Aviation Response Statement

Response to the Request for Further Information from An Bord Pleanála on the Ballycar Green Energy Ltd Strategic Infrastructure Development Application

Case Reference ABP-318943-24 / Ballycar Green Energy Limited

Figure 8: Shadow Region Caused by Terrain beyond Wind Farm

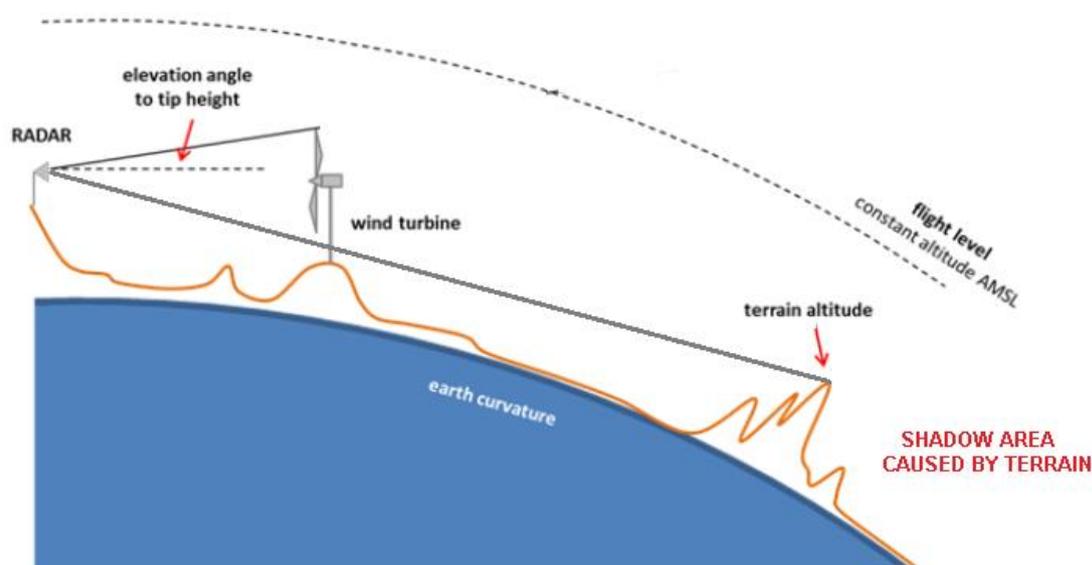
In Figure 8 below it is shown that shadowing of radar signals can be caused by terrain (hills/mountains) beyond the wind farm. This is later shown to be the case where there is shadowing caused by the Slieve Bloom range on the radar signal from the Woodcock Hill Radar.

Figure 9: Altitude of Shadow Region and Minimum Flying Altitudes

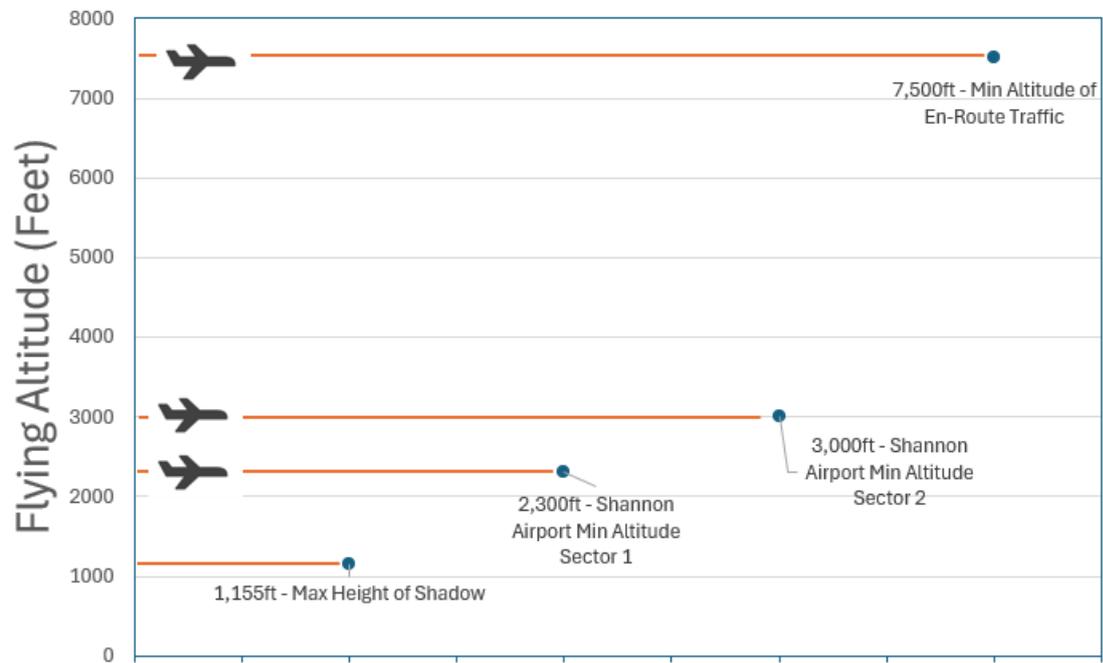
Based on Shannon Airport's ATC Surveillance Minimum Altitude Chart, as published by the Irish Aviation Authority, turbines T1 to T10 of the Ballycar wind farm are within Sector 1 where the minimum flying altitude is 2,300 feet AMSL. Turbines T11 and T12 are in Sector 2 where the minimum altitude is 3,000 feet AMSL. Aircraft at these minimum altitudes will not be low enough for the shadow regions to have any impact, as the calculated worst case shadow will extend to 1,115 feet AMSL.

Therefore, the shadow regions that may be generated beyond the proposed turbines will not extend into airspace where aircraft are flying (see Figure 9 below).

As concluded in Section 3.5.3 above, any potential shadows generated from the Ballycar wind farm will be limited to a height of 1,115 feet AMSL. The minimum flying height for en-route traffic through controlled Irish airspace is 7,500 feet. Therefore, there is no possibility for any shadowing impacts from the Ballycar wind farm on En-route traffic, which will not result in any compromise to the Woodcock Hill MSSR EU mandated surveillance performance criteria required to support 5 Nautical Mile horizontal separation of aircraft in En-route airspace. Figure 9 graphically represents this.

Figure 13: Woodcock Hill radar service coverage at 35,000ft – with turbines

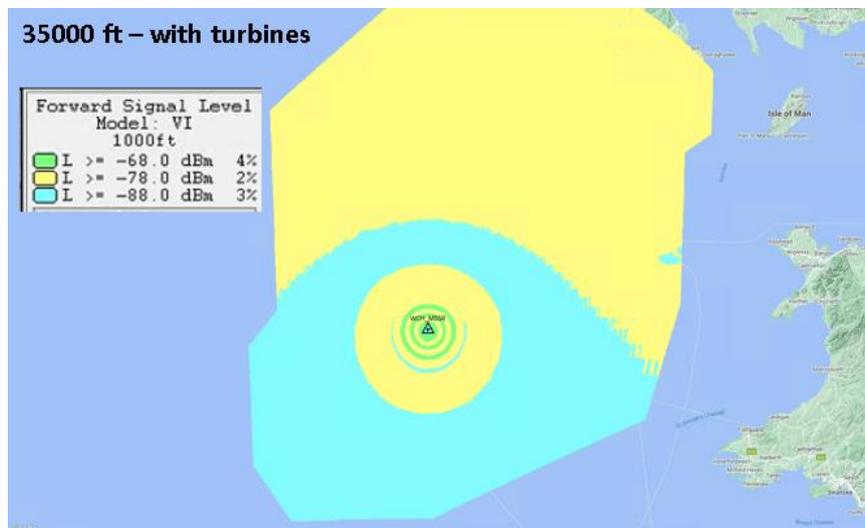
Additional analysis from Cyrrus in relation to shadow regions identifies that while there may be some limited shadowing behind the Ballycar wind farm, there will be no shadowing impact to Woodcock Hill Radar Surveillance of En-route aircraft at heights of 7,500 to 35,000ft. Radar Service coverage plots are shown in Figures 12 and 13 below at En-route flight levels of 35,000 ft (FL350) showing no impact.

Figure 14: Graphic showing the conical zone of silence over Woodcock Hill Radar

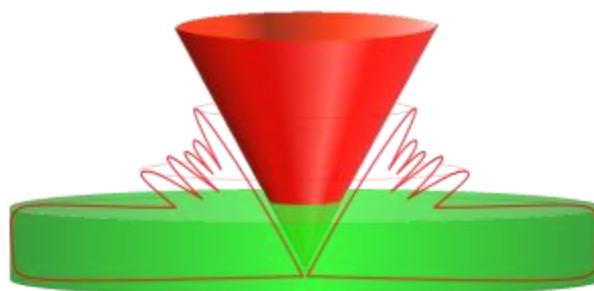
At the meeting with AirNav officials in May 2024, there were a number of points made in relation to the Woodcock Hill radar range and which have been documented and shown in Appendix 6. One of the points made was in relation the cone of silence of the radar. There is an area above ground based radar system that does not track En-route traffic and this is also the case for the Woodcock Hill MSSR. In essence, the radar cannot see above itself and therefore, cannot track aircraft through this area. This is referred to as the conical zone of silence. All radar in the state will have these “non-coverage” areas and this is demonstrated in the graphic below in Figure 14 (for demonstrative purposes only).

Due to this cone of silence, overlapping radar coverage from multiple radar systems is required to ensure surveillance and tracking of aircraft through this zone. In the event of a failure of a radar in any part of the state there is overlapping coverage from another alternate radar providing identical radar surveillance which all feed into the air traffic control systems. Figure 15 below illustrates the coverage area over Woodcock Hill from various other radars.

Figure 15: Overlapping Coverage Map shows that there is multi radar tracking capability of the AirNav Radar equipment i.e. if Woodcock Hill MSSR were to fail/undergo maintenance there is overlapping coverage from Dooncarton, Cork Airport, Mt Gabriel

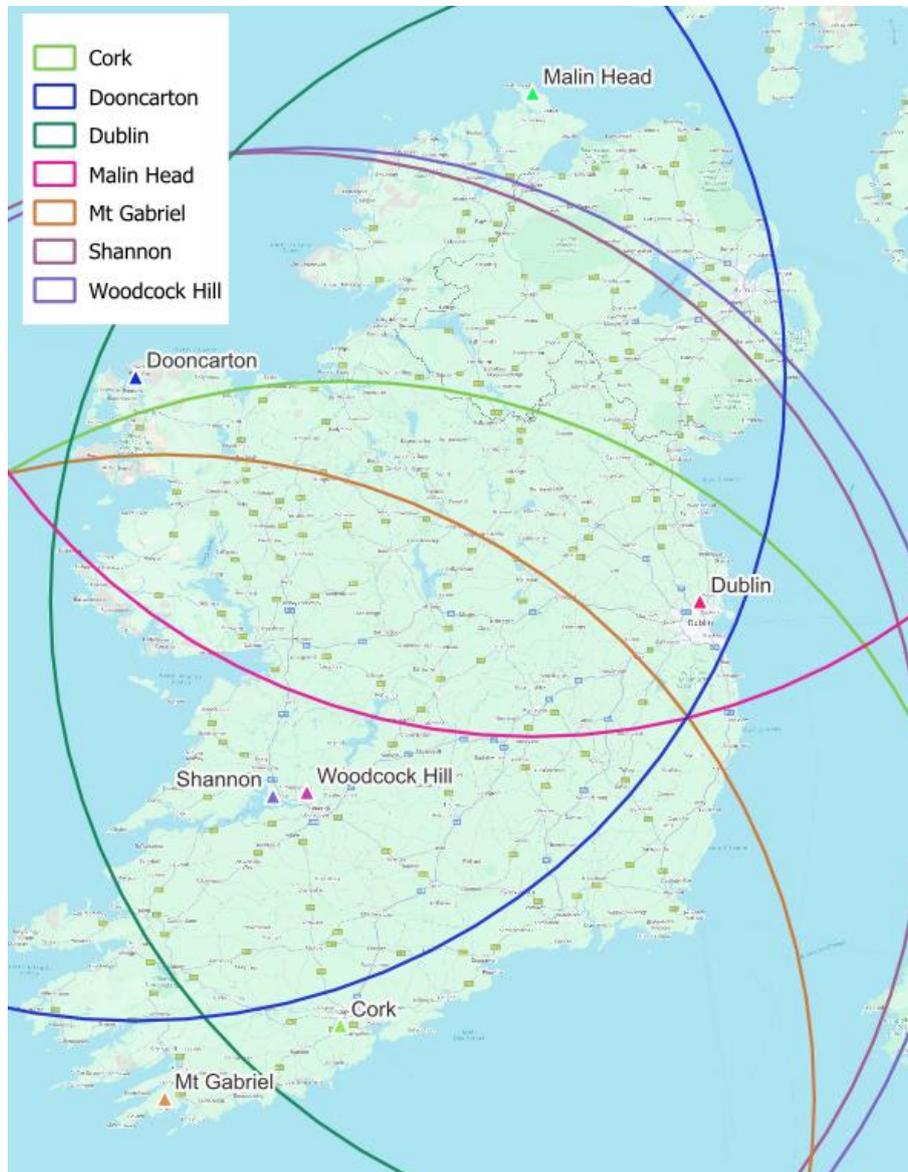
As previously discussed, the ARTAS system used by AirNav Ireland merges the radar data and distributes the appropriate air situation picture to the controllers. Therefore, it has the ability to incorporate data from other radar systems to provide coverage over the cone of silence

Figure 16: Radar Signal Path from Woodcock Hill – Dublin Airport Terminal Area

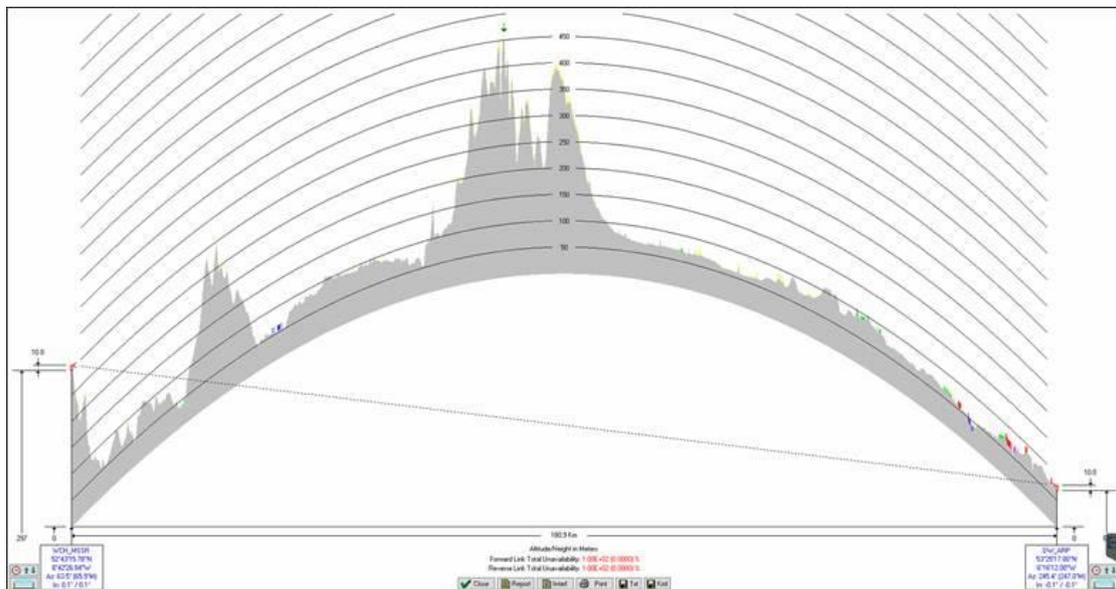
Figure 16 below outlines the radar signal path from Woodcock Hill to the Dublin Airport Terminal area. As referenced earlier in section 3.4.3 there is terrain blocking due to the Slieve Bloom Mountain range which screens any potentials impacts from the Ballycar wind farm from projecting aircraft tracking issues into the En-route airspace in the vicinity of Dublin Airport.
